**Request for Additional Information No. 133, Supplement 2**

**U. S. EPR Standard Design Certification**

**Docket No. 52-020**

**SRP Section: 19 - Probabilistic Risk Assessment and Severe Accident Evaluation**

**Figure 19-232c-1—Mass Fraction of SrO Released to Environment – Cases with 1m<sup>2</sup> Isolation Failure Area With & Without MCCI**

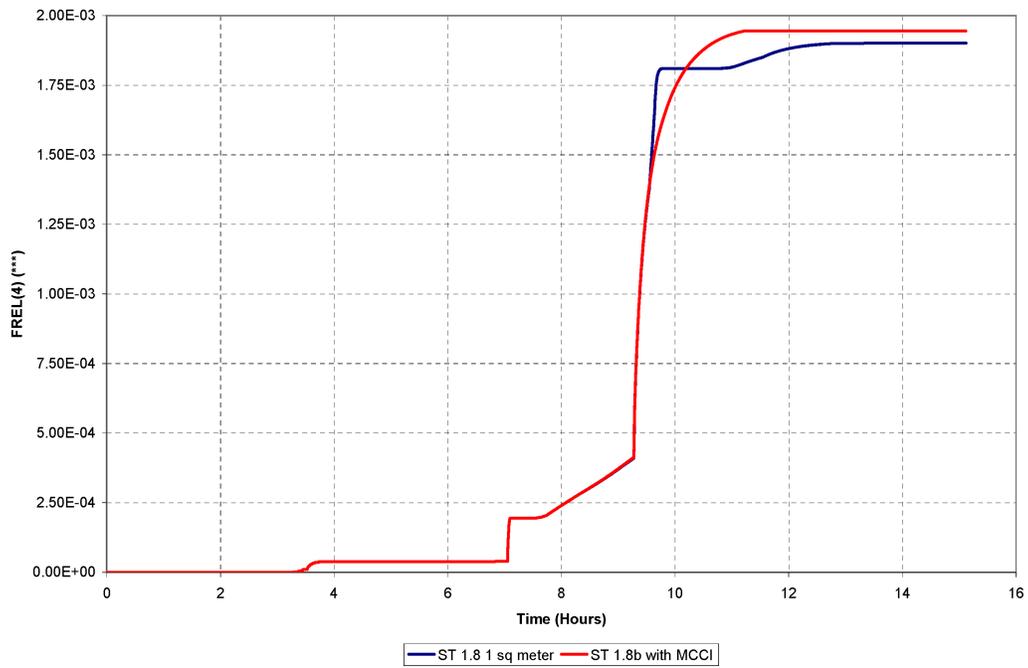
- c. In addition, in discussing the effects of molten corium-to-concrete interaction (MCCI), the response refers to Figures 19-84d-11 and 13 depicting lower values of SrO releases for cases involving MCCI as compared to accidents where MCCI is prevented. Please explain the phenomenological processes causing this apparent anomaly.

Additional sensitivity cases have been performed to investigate the apparent anomaly.

When large amounts of MCCI were examined, the basemat thickness was increased from 0.1 meters to 5 meters and flooding was disabled. Because the basemat is defined in MAAP as a heat sink, the change from 0.1 meters to 5 meters incurred a large increase in the size of the nodalization array that represents the basemat. This alteration in array size influenced the calculation of some of the events calculated during the transient. This was confirmed by the examination of four cases (permutations of 0.1 meter or 5 meter basemat and passive flooding allowed or not) where the transients did not exhibit the same traces until the time when the corium enters the spreading area.

Because the transients are the same until melt plug failure, the MAAP calculation was modified to remove the influence that the basemat thickness has on the events of the transient prior to the time when the corium enters the spreading area. Therefore, the MAAP runs for the 1 square meter isolation failure area were performed with the identical inputs for the basemat up to the point where the corium enters the spreading area. At this point, the case without flooding (where MCCI was expected) was restarted with the 5 meter basemat, while the case with flooding was allowed to continue.

The impact of the thicker basemat on the calculational time step was confined to the time when MCCI was expected. The 1 inch failure area cases were treated similarly.

Figure 19-232c-1 and Figure 19-232c-2 show revised SrO releases for cases involving MCCI compared to accidents where MCCI is prevented. The plots show higher values of SrO release for cases involving MCCI, which is the expected result and removes the anomaly found previously.

**Figure 19-233-1—Primary pressure (Pa) for multiple SGTR runs**

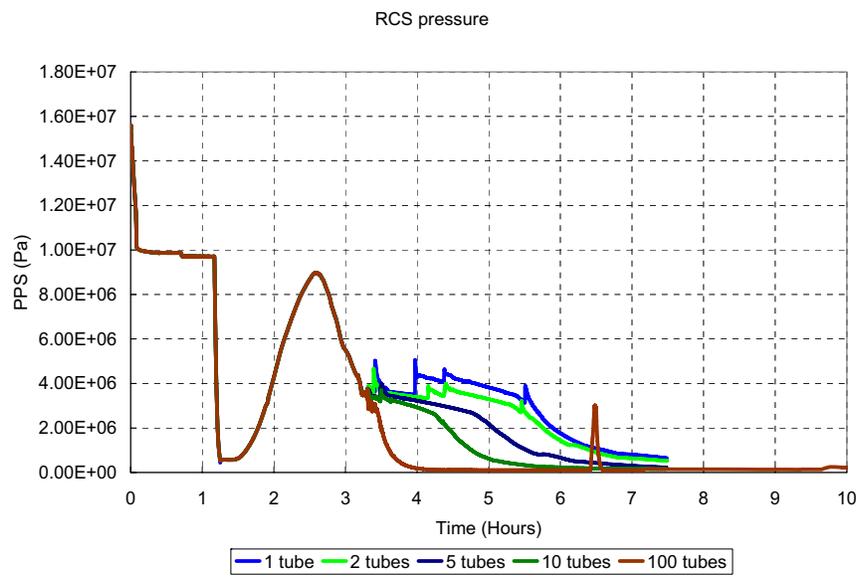
(Follow-up to Question 19-84e) The response to Question 19-84e discusses the assumptions applicable to analysis of steam generator tube rupture (SGTR) source terms (i.e., Release Category 702). The response confirms that the analysis assumes the failure of a single tube, whereas the results of a preliminary sensitivity study by AREVA shows the increase in fission product source term under the postulated condition of more than a single tube rupture. Please address the likelihood for multiple SGTRs and provide associated source terms.

A series of representative MAAP cases with multiple creep-induced SGTRs following a 2 inch cold leg loss of coolant accident (LOCA) with station blackout (SBO) were analyzed. Runs with 1, 2, 5, 10, and 100 tubes ruptures were performed.

Figure 19-233-1 shows the primary pressure for each case. The 100 tube ruptures case shows a significant depressurization of the primary system following the ruptures. Therefore, the rupture of 100 tubes precludes any further induced SGTR.

**Figure 19-240(2)-1—Steam Generator Tube Damage Fractions for SBO scenario with secondary depressurized and 50% tube wall thinning**

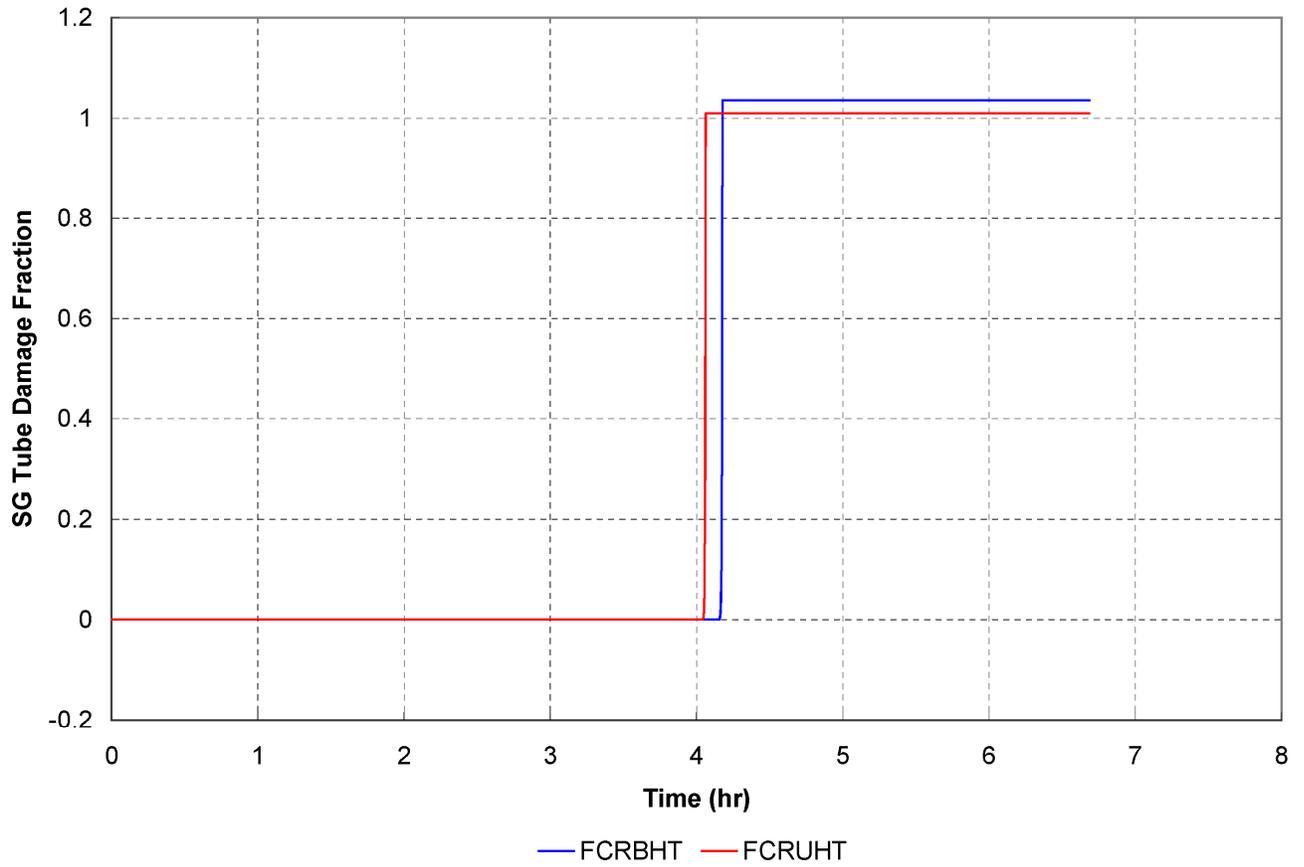
2. More information is needed to clarify the response to question 19-79a, as summarized below.
  - Since cases where the secondary side is depressurized dominate the risk in current PWRs, please run a variation of the MAAP base case with degraded tubes where the steam generators are depressurized and report the damage fractions and the times of predicted hot leg failure, tube failure, and when the core outlet temperature reaches 650 C. Also provide plots of the steam generator tube temperatures.

A variation of the base station blackout (SBO) modular accident analysis program (MAAP) case is run with secondary side depressurized and 50 percent steam generator (SG) wall thinning. Table 19-240(2)-1 shows relevant timings for this run. MAAP predicts hot leg rupture to occur at about 3.8 hours and SG tube rupture after four hours. Even with tube wall thinning, hot leg rupture still precludes SG tube rupture (SGTR).

Figure 19-240(2)-1 shows SG tube creep damage fractions for the unbroken (FCRUHT) and broken (FCRBHT) loops. Figure 19-240(2)-2 shows SG gas and metal tube temperatures for the unbroken and broken loops.
